AMENDMENT OF SOLICITATION/MODIFICATION OF CONTRACT			1. CONTRACT ID CODE	PAGE OF PAGES 1 29
2. AMENDMENT/MODIFICATION NO. 003	3. EFFECTIVE DATE See Block 16C	4. REQUISITION/PURCHASE REQ. NO. 4200457725	5. PROJECT NO. (If applicable) PCN 98986	
6. ISSUED BY NASA/Kennedy Space Center Office of Procurement, OP-ES Andrew Dennis Kennedy Space Center, FL 32899	CODE	7. ADMINISTERED BY (If other than item 6)	CODE	
8. NAME AND ADDRESS OF CONTRACTOR (No., street, county, State and ZIP Code)		(X)	9A. AMENDMENT OF SOLICITATION NO. NNK13457725R	
		(X)	9B. DATED (SEE ITEM 11) February 1, 2013	
			10A. MODIFICATION OF CONTRACT/ORDER NO.	
			10B. DATED (SEE ITEM 13)	
CODE	FACILITY CODE

The purpose of this amendment is to add reference drawings, extend the closing submission date for Part 2 (Price Volume), document answers provided to questions received, and revise the Solicitation in accordance with the answers provided.

Number: K0000135925
Title: Mobile Launcher Modifications for SLS
Date: 100%, February 28, 2013
No. of Sheets: 308

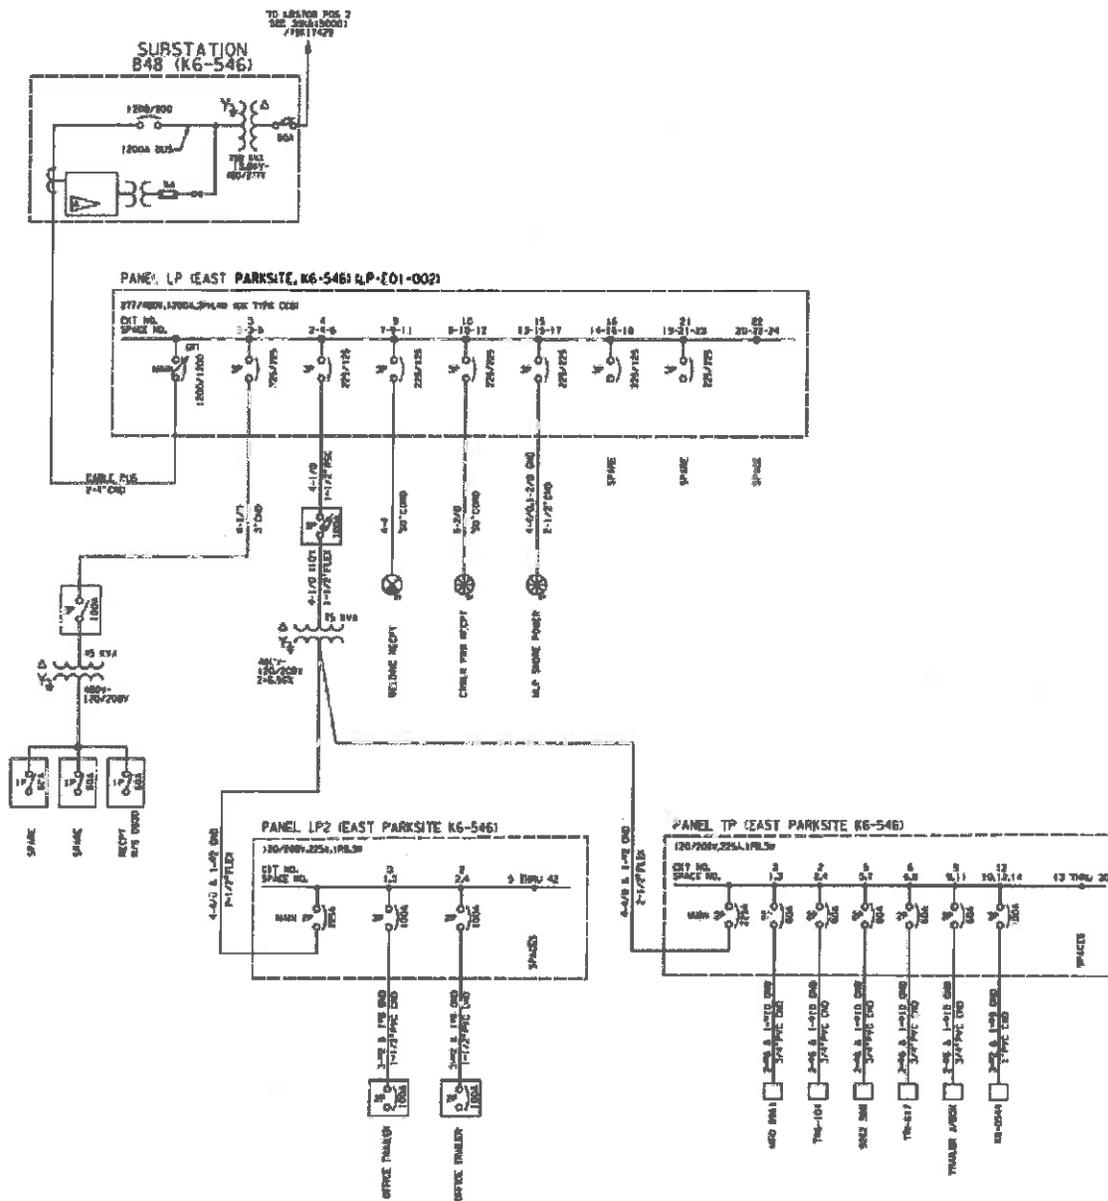
68. REFERENCE: Electrical Conduit Supports
If unistrut is used for interior conduit supports, can standard conduit clamps be utilized or will u-bolts with flex-loc nuts be required?

Response: Provide U-bolts with flex-loc or double nut ends for conduit attachments to Unistrut.
